DEPARTMENT OF COMMERCE**National Oceanic and Atmospheric Administration**

RIN 0648-XA804

Takes of Marine Mammals Incidental to Specified Activities; Taking Marine Mammals Incidental to an Exploration Drilling Program Near Camden Bay, Beaufort Sea, Alaska

ACTION: Notice; issuance of an incidental harassment authorization.

Figure 1. Band levels for the Kulluk during drilling.

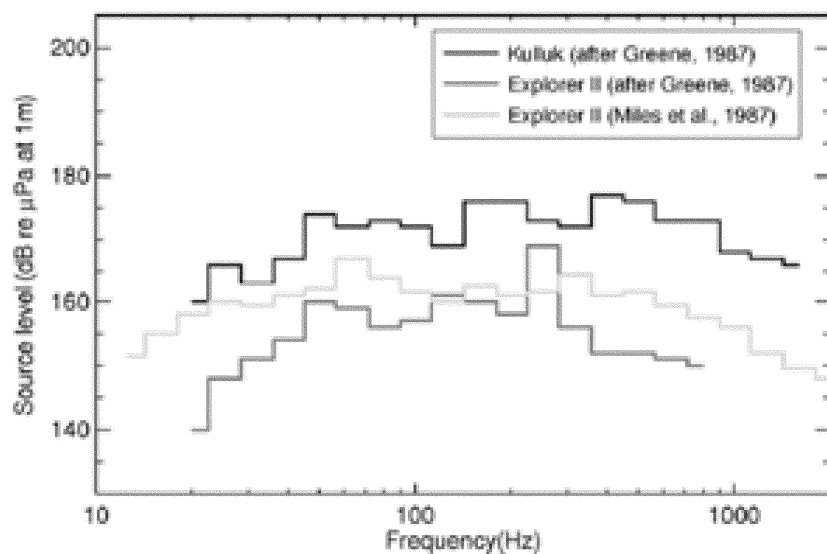
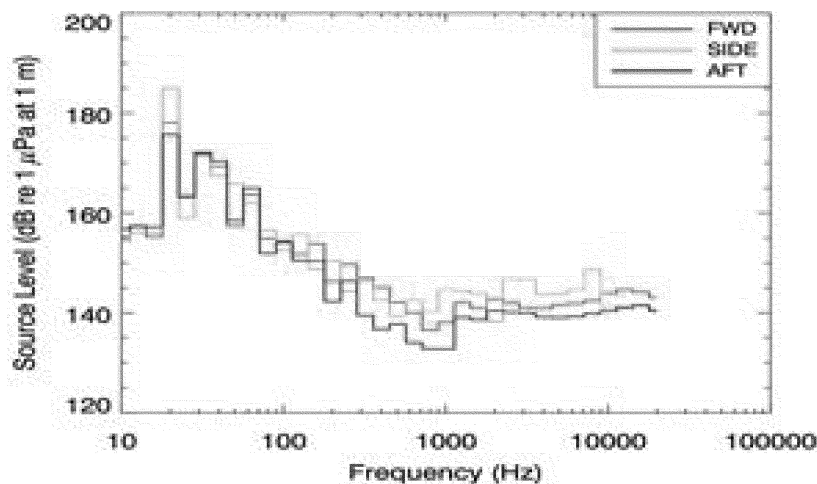
Comment 4: The MMC and AWL question the source levels and harassment zones for the two drillships. If the source levels for the *Kulluk* and *Discoverer* are nearly identical, then why is there a four-fold difference in the size of the corrected harassment zones for the two drilling vessels?

Response: Differences in sound propagation from the two rigs are real and are caused by differences in the design of the two vessels. While the broadband source levels for the

Discoverer and *Kulluk* may be similar, their spectral properties differ considerably. Acoustic modeling considers the source levels in 1/3-octave frequency bands. Figures 1 and 2 show the band levels for both drillships during drilling. Of key importance are the significantly lower levels of the *Discoverer* in the 50 to 500 Hz bands that propagate well in the relatively shallow waters of these drilling operations. While the *Discoverer* apparently has higher band levels below 50 Hz, this energy is more rapidly attenuated than higher frequency sound energy. This characteristic of sound propagation in shallow waters leads to predominantly mid-frequency sounds (50–500 Hz) dominating the acoustic field at distance from the drillships. A further consideration is that the *Kulluk* source levels are known to include contributions from support vessels, and much of the mid-high frequency band energy in its source levels may not originate entirely from the drillship itself, as acknowledged by Greene (1987). The *Discoverer* source level measurements by Austin and Warner (2010) were made at closer distances and do not include significant contributions from other vessels. The *Kulluk*'s modeled sound footprint may be an overestimate as a result, but we cannot quantify by how much since the relative contribution of vessel noise to its source level measurements is unknown. The source level for the *Discoverer* was measured, though not in the Beaufort Sea, and those measurements were used to model propagation in the Beaufort Sea environment. Regardless of which drill rig is used by Shell in the Beaufort Sea in 2012, the IHA requires Shell to conduct sound source verification (SSV) and characterization tests on all equipment used.

Figure 3. Sound speed profile used in drill rig modeling.

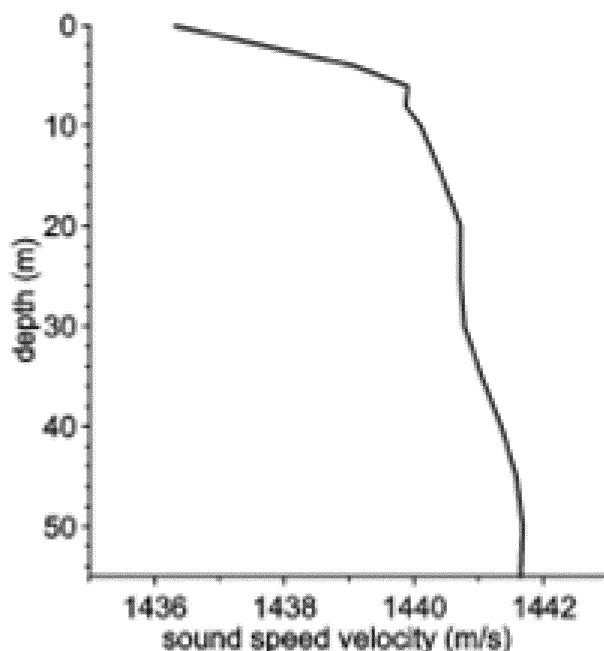
Comment 26: Dr. Bain states that the correction factor of 1.5 applied to the distance to the 120 dB contour is inadequate to conservatively account for the variability.

Response: The concern raised here is that the sound speed profile used for acoustic modeling of drill rig noise may not account for changes to the salinity and temperature profile that could influence and create variability in sound propagation, and the resulting variability might lead to conditions in which model estimates would not be conservative. While significant structure can form in the sound speed profile, the profile used for this modeling study was taken from the GDEM database for the corresponding locations and timing (month of September was used). The specific profile chosen (see Figure 3) has increasing sound speed with depth over the full water column. This profile leads to upward acoustic refraction that causes propagating sounds to bend up, thereby reducing interactions with the seabed. This situation generally reduces acoustic transmission loss as a result of acoustic energy being lost due to reflection and scattering from the bottom. It is believed to produce longer propagation distances than the stratified profile that sometimes forms with warmer high speed water overlying cooler water. That profile would be downward-refracting and would lead to more bottom interaction and sound energy loss. Therefore, a correction factor of 1.5 is appropriate in this circumstance.
